## **ALERT Service Bulletin – Product Recall Action – ASB2010/03/01**

SL10-532/BTT

ASB2010/03/01

Figure 1: shaft grinding on the turbine shaft on a NR12/S turbocharger

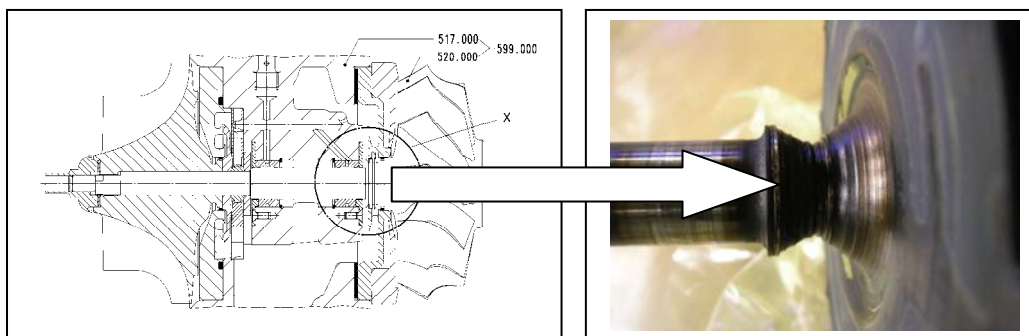
<b>Compliance</b>	<b>Mandatory</b>
<b>Description</b>	We identified in certain productions lots (above mentioned) of TCR20, TCR22 and NR12/S, that the piston ring groove is in the wrong position on the shaft. Therefore it can happen at certain operation load conditions that the turbine wheel material melts on the piston ring.

In consequence of the damaged shaft sealing oil can enter the hot turbine inlet casing with the potential risk of a fire in the exhaust pipe or funnel. For this reason a new locating ring repair kit was designed which avoids this failure.

Figure 2: previous design

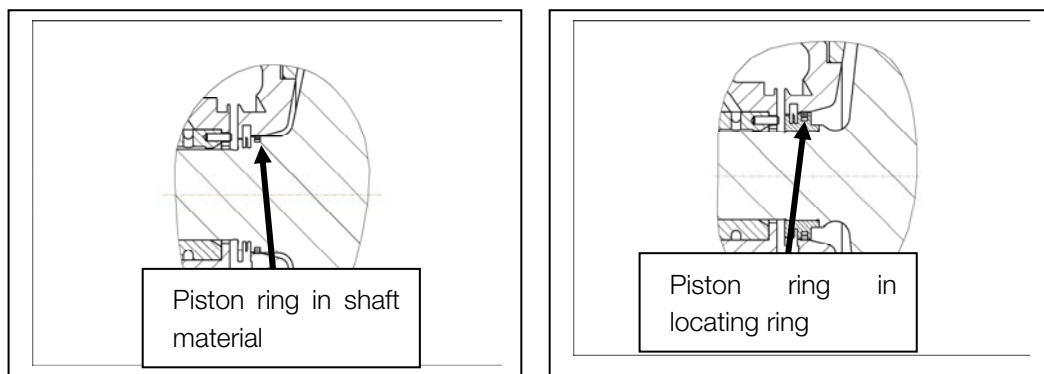
The above listed turbochargers must be updated to the improved shaft sealing with shrink fitted locating ring. For a better stiffness of the locating ring the diameter of the piston ring was increased. Therefore also the bearing casing must be updated. It is recommended to exchange the cartridge. This update has to be carried out by qualified personnel.
